## 02 Elevations

### West Podium Elevation

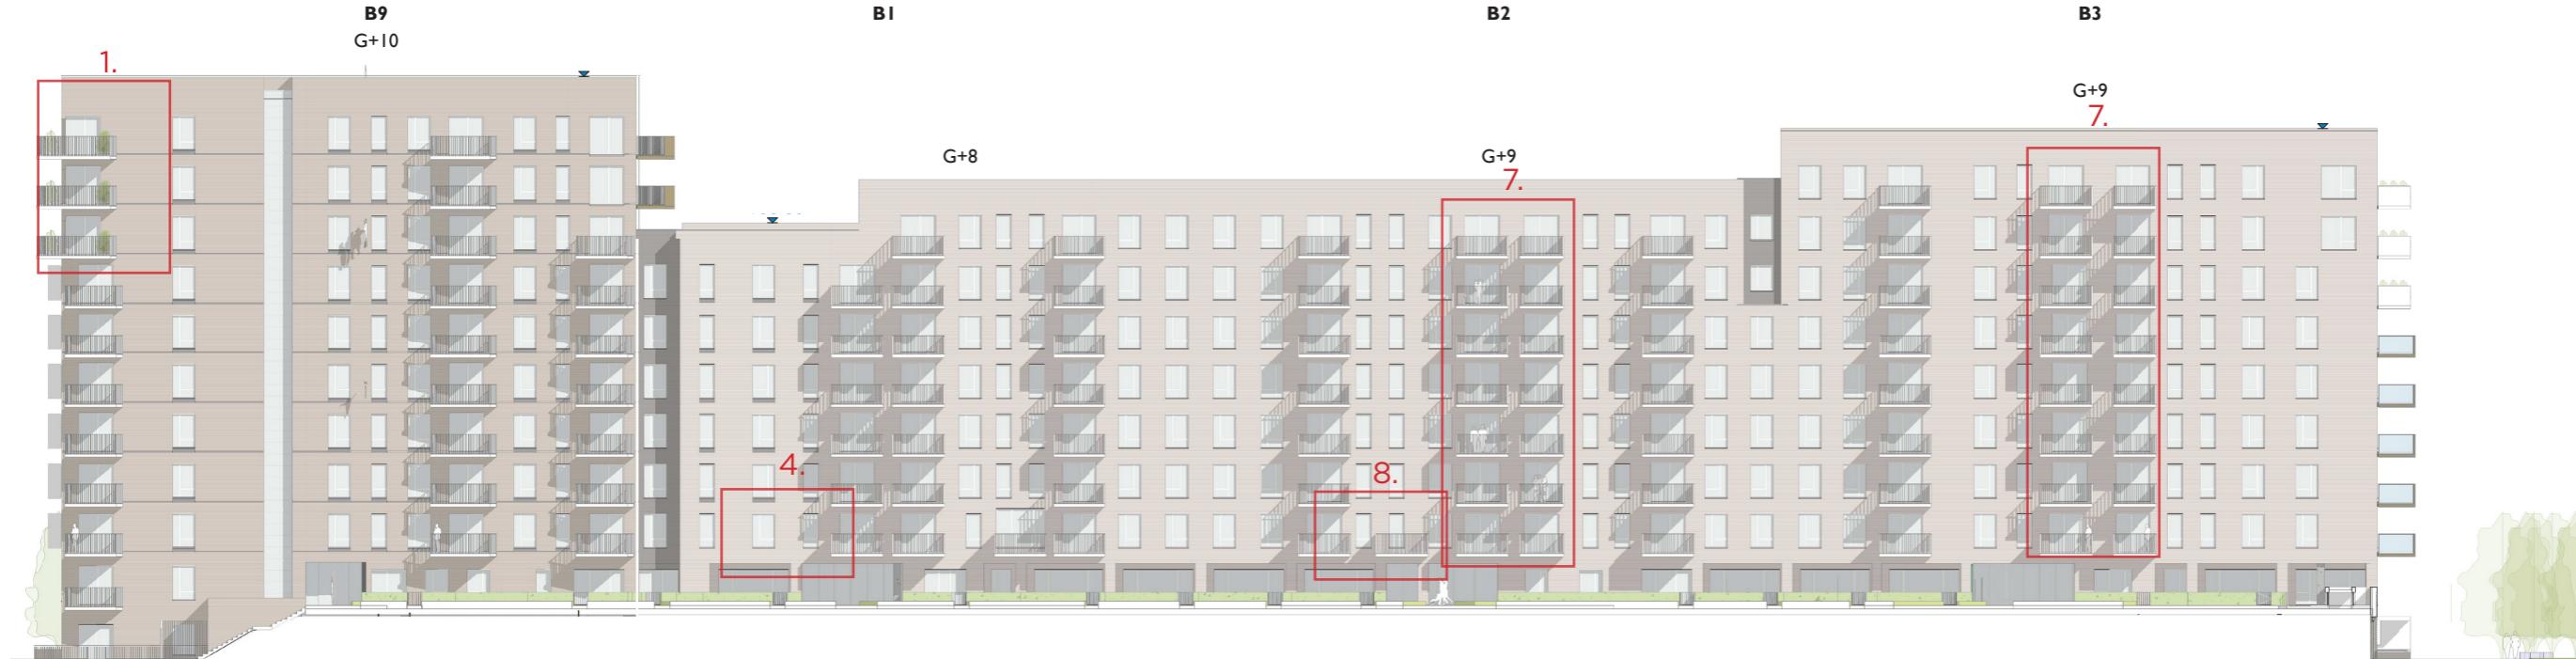
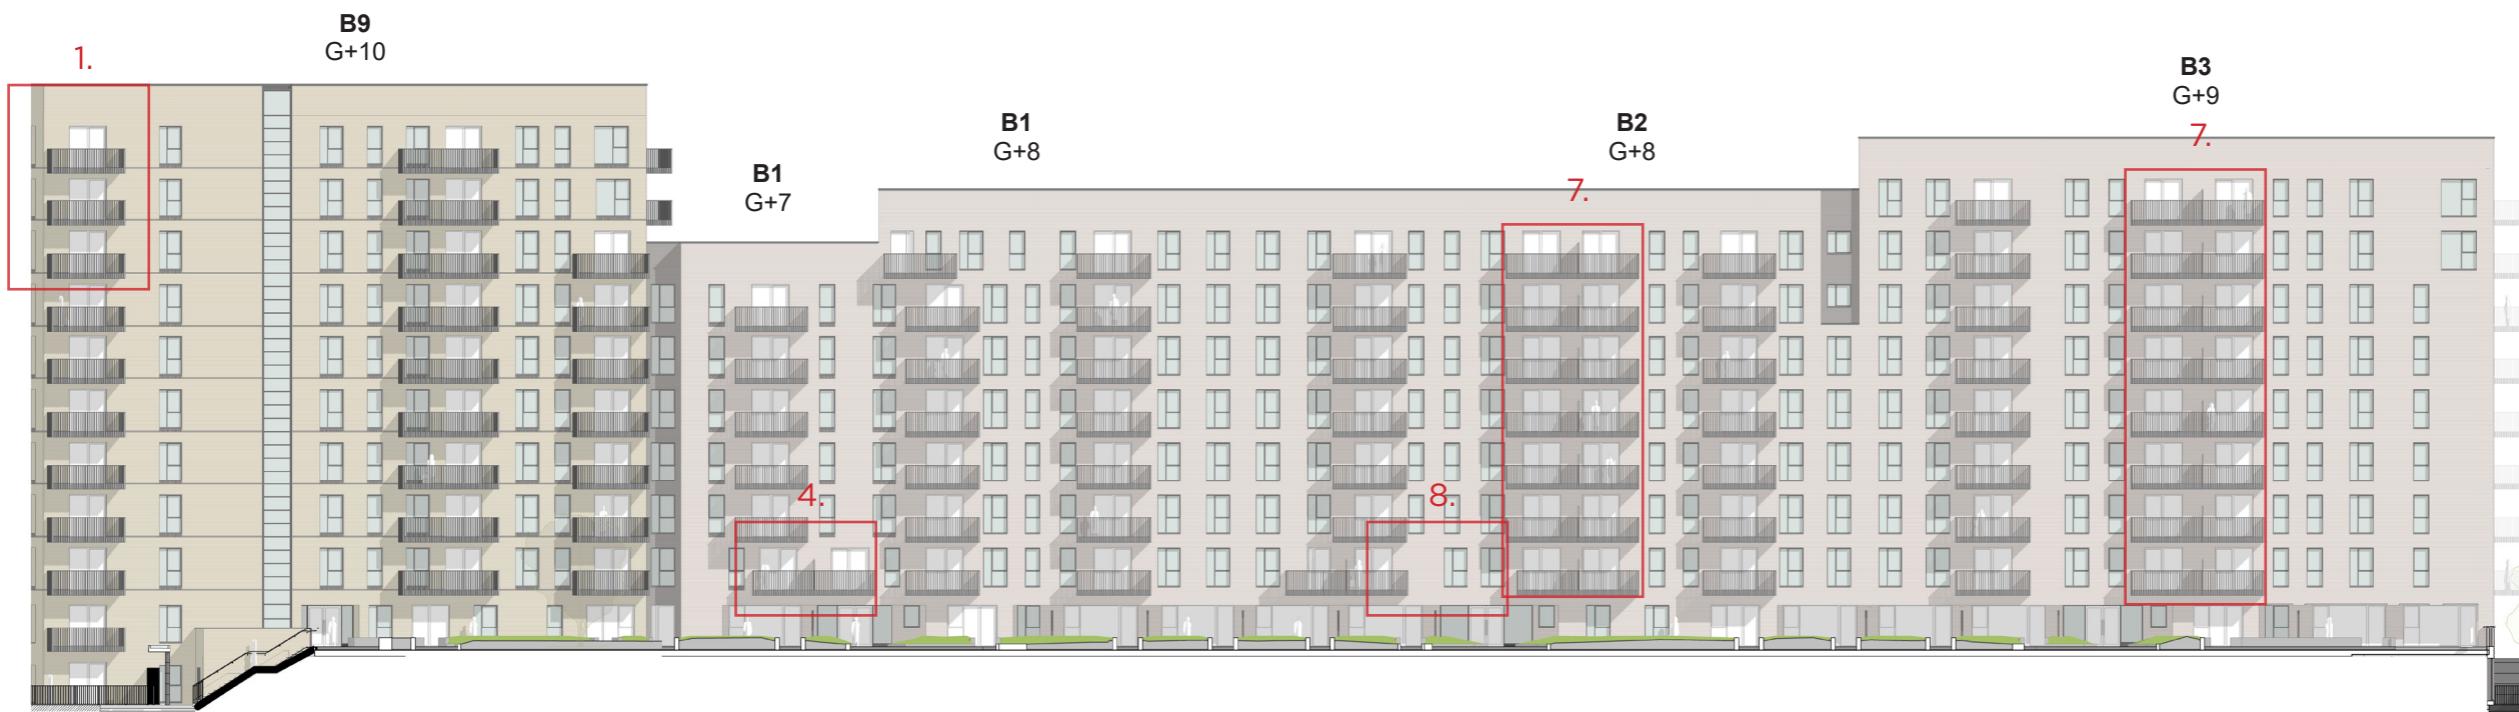
1. Rationalisation of balcony design as per previous phases
2. Windows omitted to suit developed stair/lift core design
3. Rationalisation of apartment stacking to facilitate drainage stacking / co-ordination
4. Window amended to ensure consistency between apartment type layouts
5. Window reduced to avoid internal clashes
6. Rationalisation / standardisation of balcony types
7. Balconies re-sized and linked to ensure compliance to London Plan area standards
8. Window type amended to match adjacent levels
9. Adjustment of architectural articulation

### East Podium Elevation

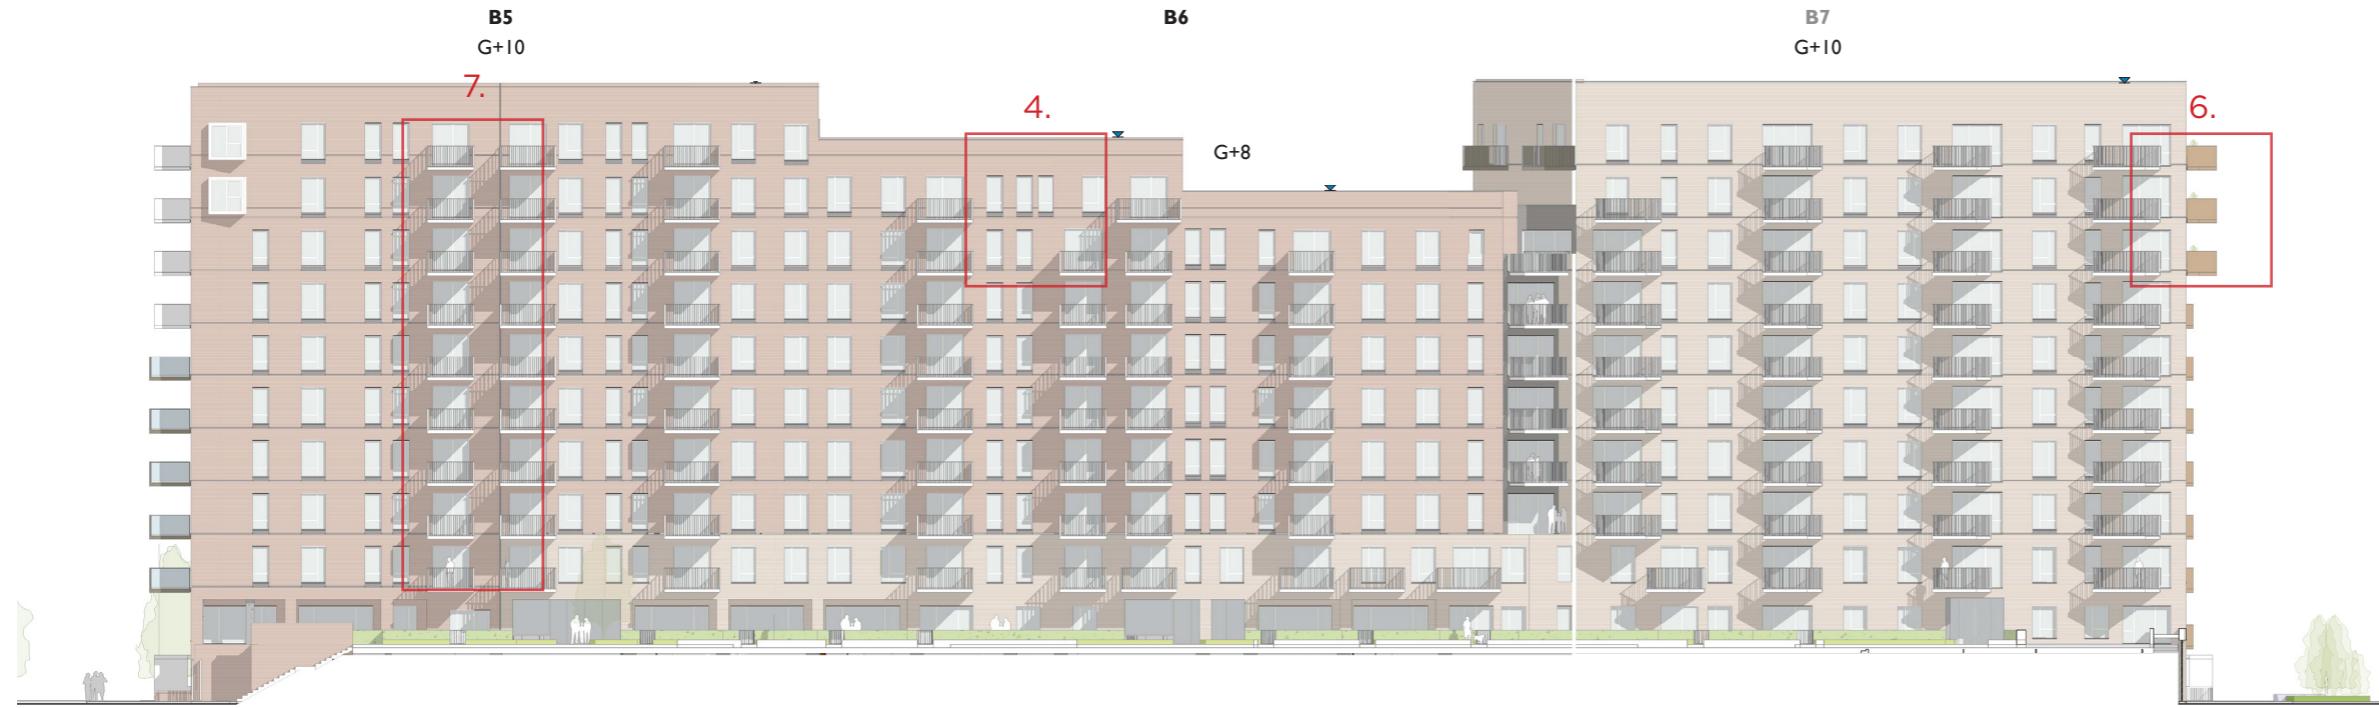
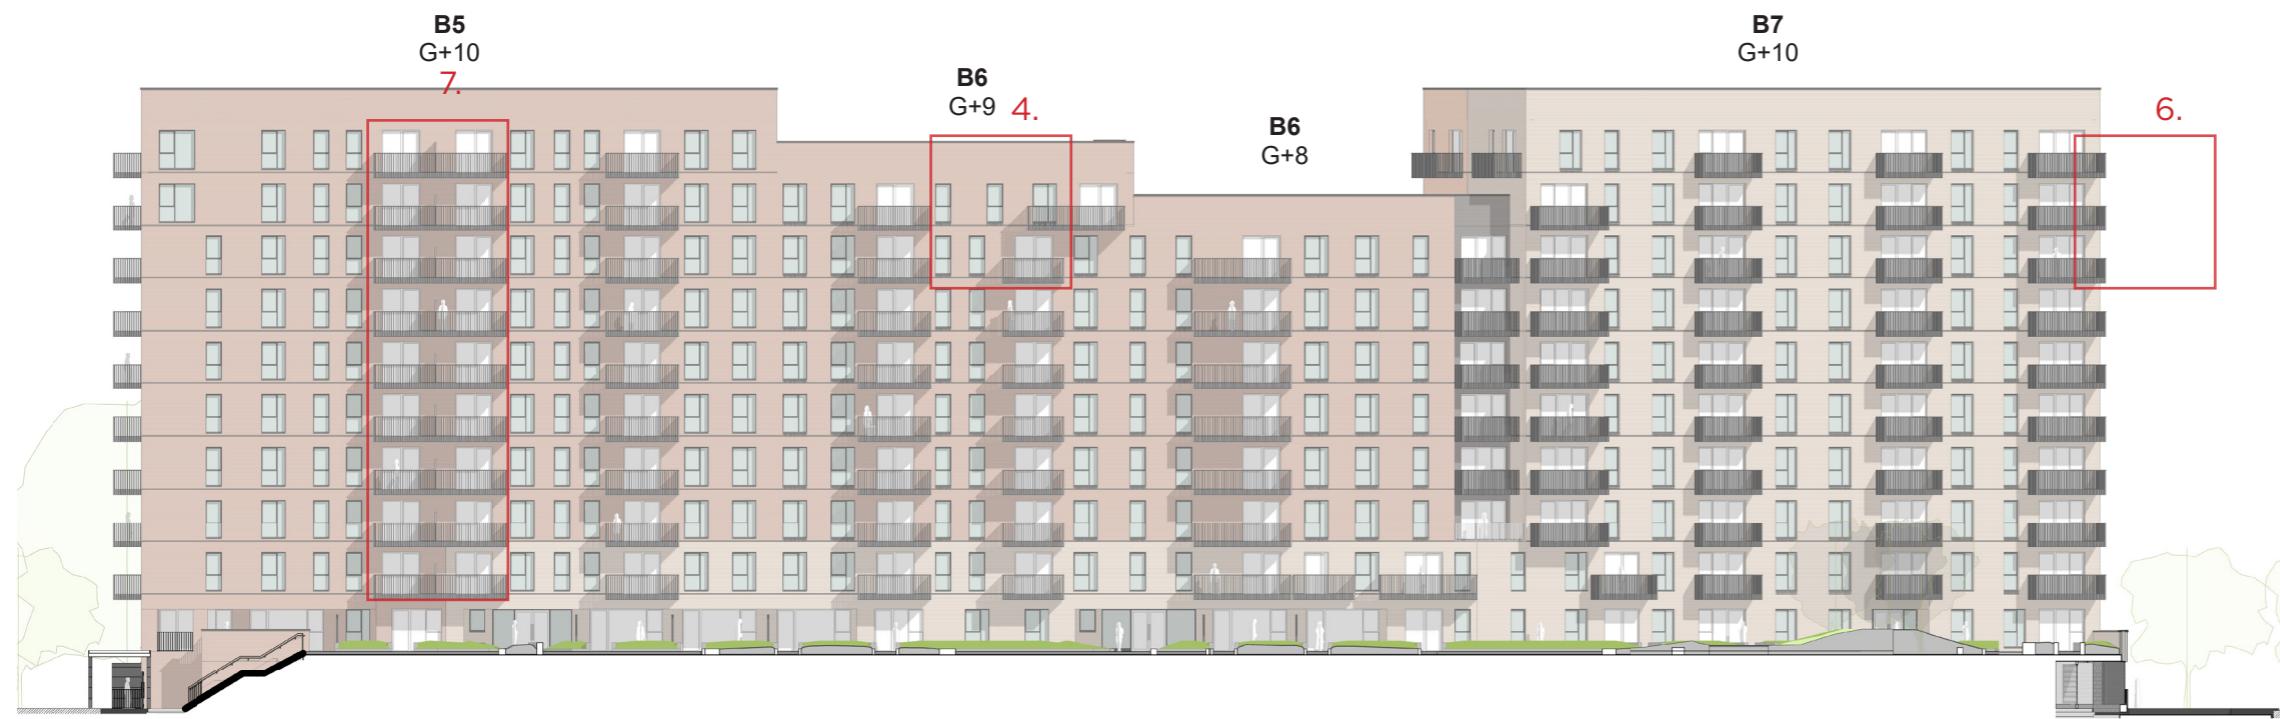
1. Rationalisation of balcony design as per previous phases
2. Windows omitted to suit developed stair/lift core design
3. Rationalisation of apartment stacking to facilitate drainage stacking / co-ordination
4. Window amended to ensure consistency between apartment type layouts
5. Window reduced to avoid internal clashes
6. Rationalisation / standardisation of balcony types
7. Balconies re-sized and linked to ensure compliance to London Plan area standards
8. Window type amended to match adjacent levels
9. Adjustment of architectural articulation

### South Podium Elevation

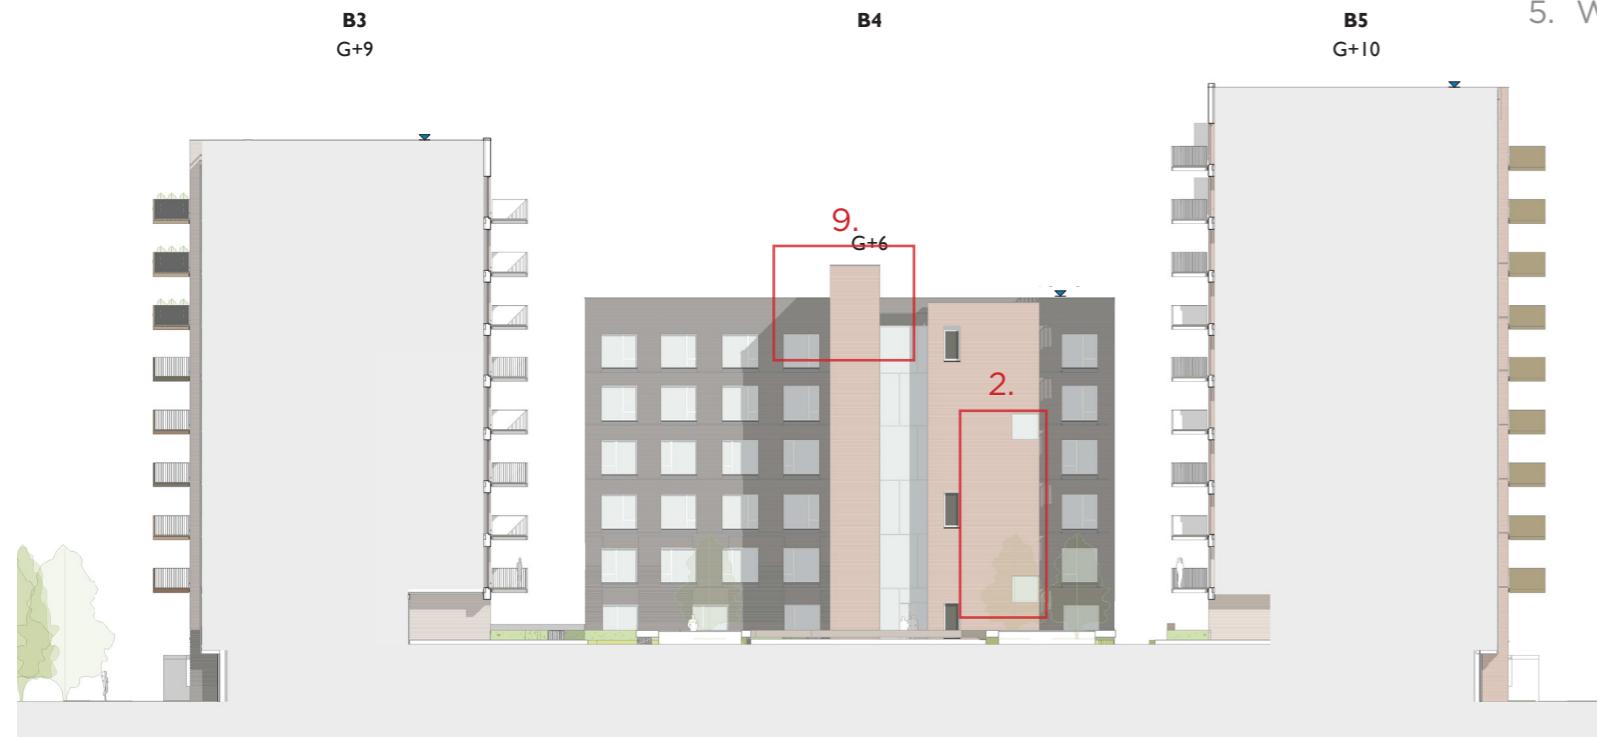
1. Rationalisation of balcony design as per previous phases
2. Windows omitted to suit developed stair/lift core design
3. Rationalisation of apartment stacking to facilitate drainage stacking / co-ordination
4. Window amended to ensure consistency between apartment type layouts
5. Window reduced to avoid internal clashes
6. Rationalisation / standardisation of balcony types
7. Balconies re-sized and linked to ensure compliance to London Plan area standards
8. Window type amended to match adjacent levels
9. Adjustment of architectural articulation

### North Podium Elevation

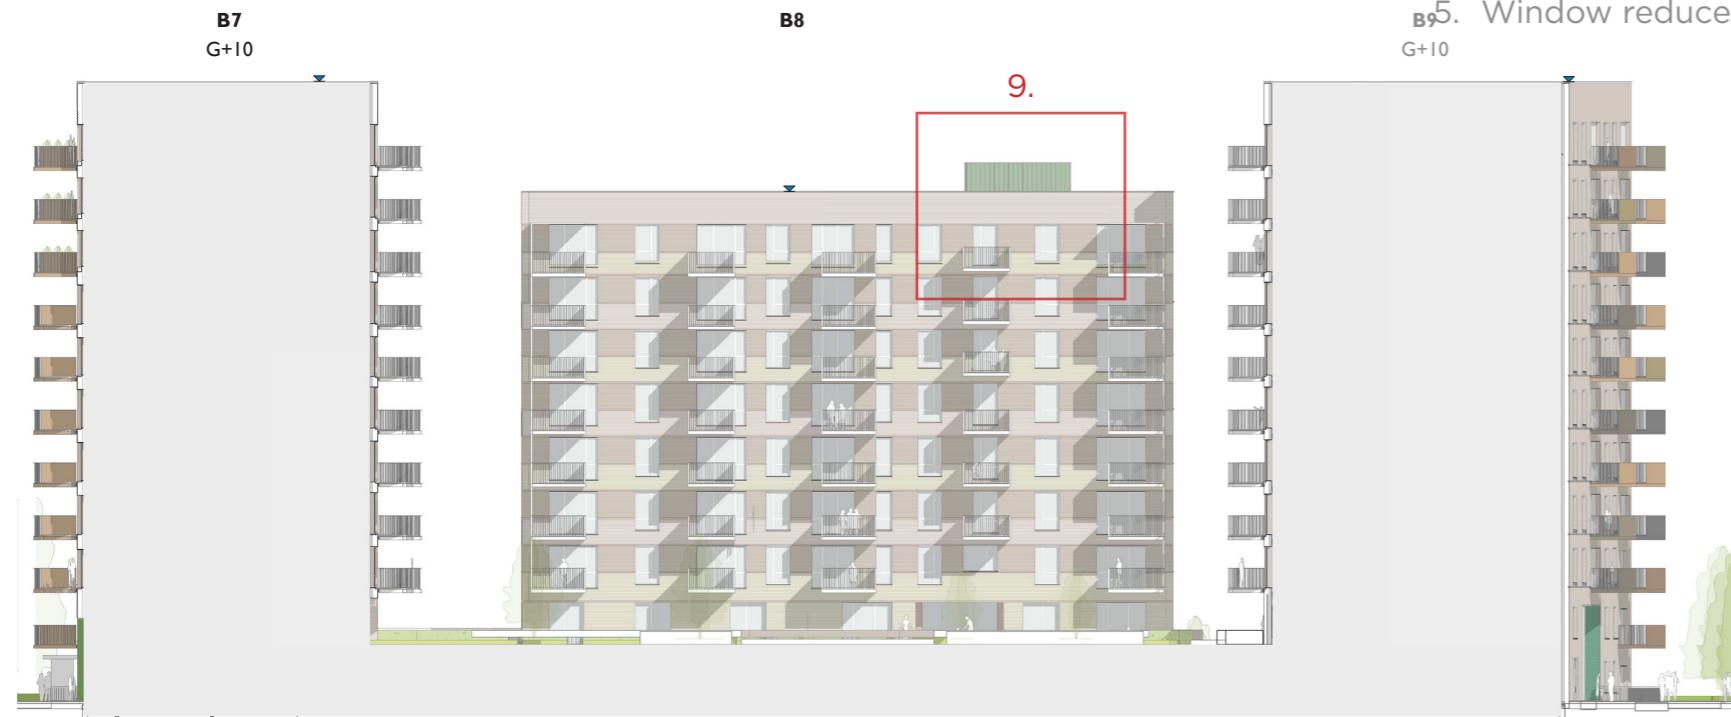
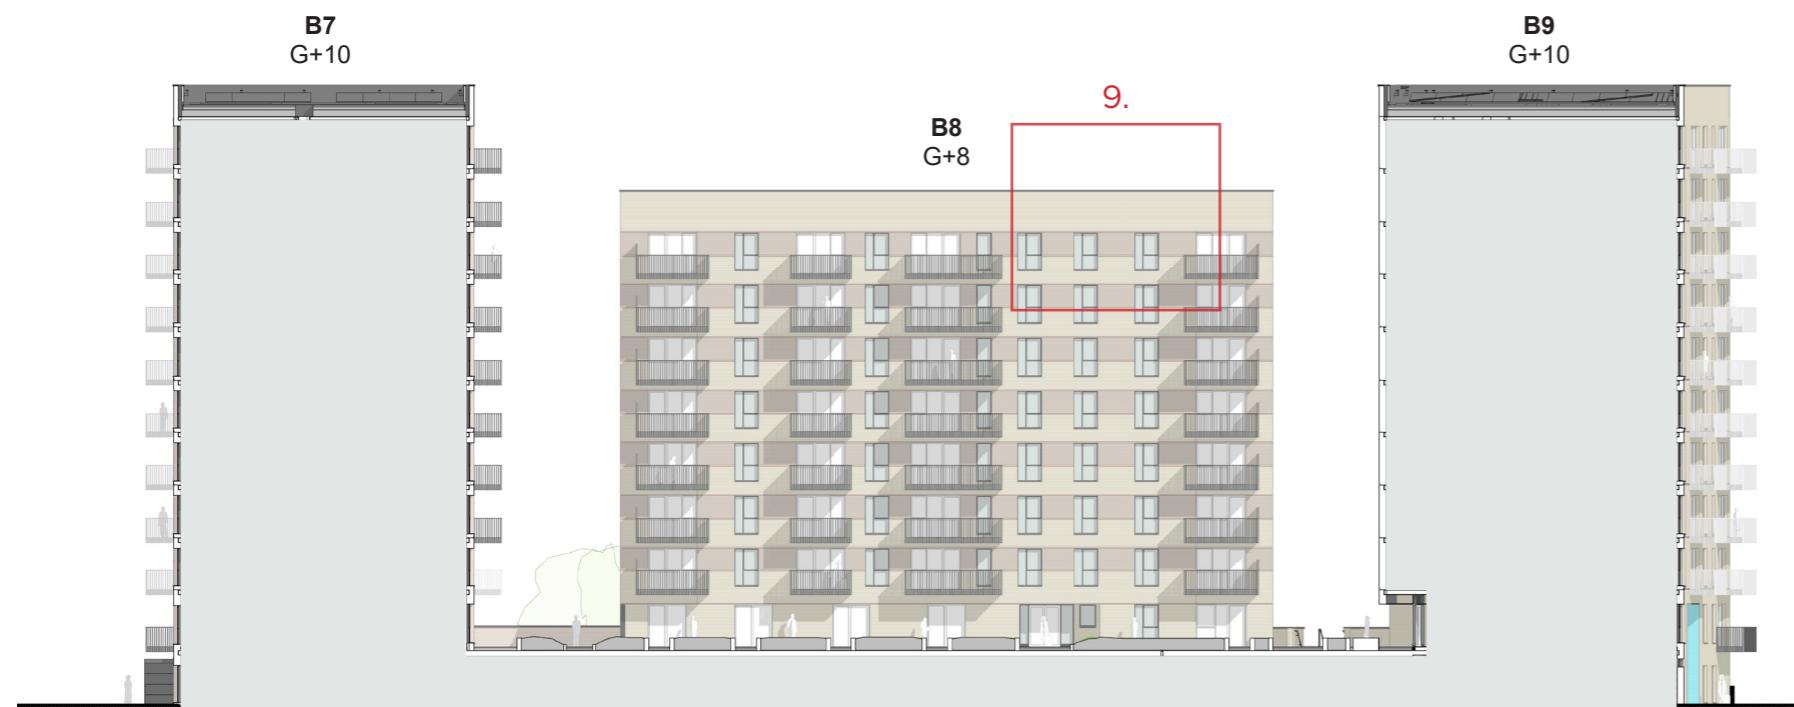
1. Rationalisation of balcony design as per previous phases
2. Windows omitted to suit developed stair/lift core design
3. Rationalisation of apartment stacking to facilitate drainage stacking / co-ordination
4. Window amended to ensure consistency between apartment type layouts
5. Window reduced to avoid internal clashes
6. Rationalisation / standardisation of balcony types
7. Balconies re-sized and linked to ensure compliance to London Plan area standards
8. Window type amended to match adjacent levels
9. Adjustment of architectural articulation
